April 16, 1992

## PLANT HATCH - UNIT 2 NRC DOCKET 50-366 OPERATING LICENSE NPF-5 PRIMARY CONTAINMENT HARDENED VENT NRC TAC No. M74870

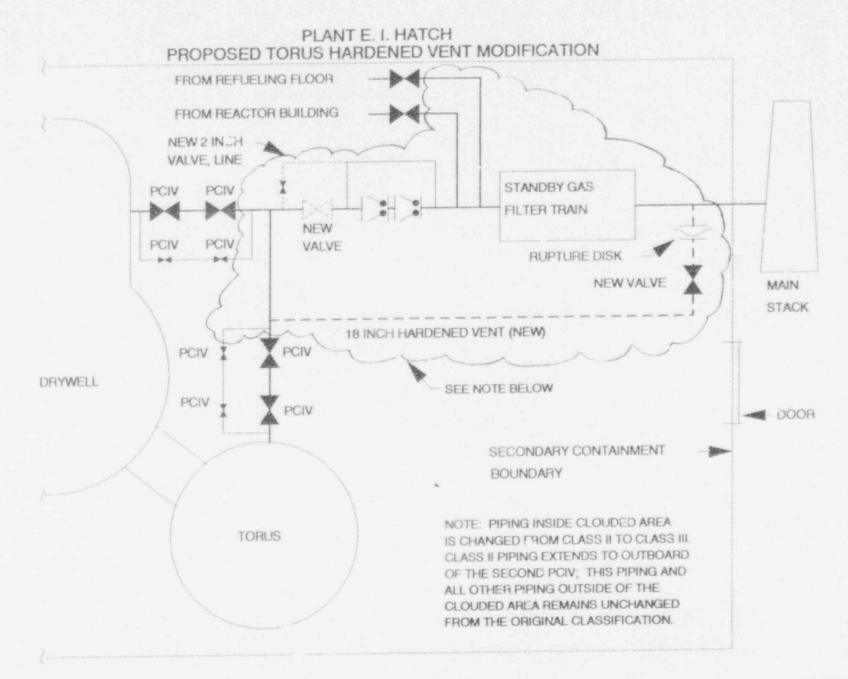
Second, Standby Gas Treatment (SBGT) System piping outboard of the second primary containment isolation valve will be reclassified from ASME Section III, Class II to Class III, and the new primary containment nardened vent system will be installed to Class III standards. A simplified sketch showing the location of the hardened vent and pipe classification boundaries is enclosed for your information.
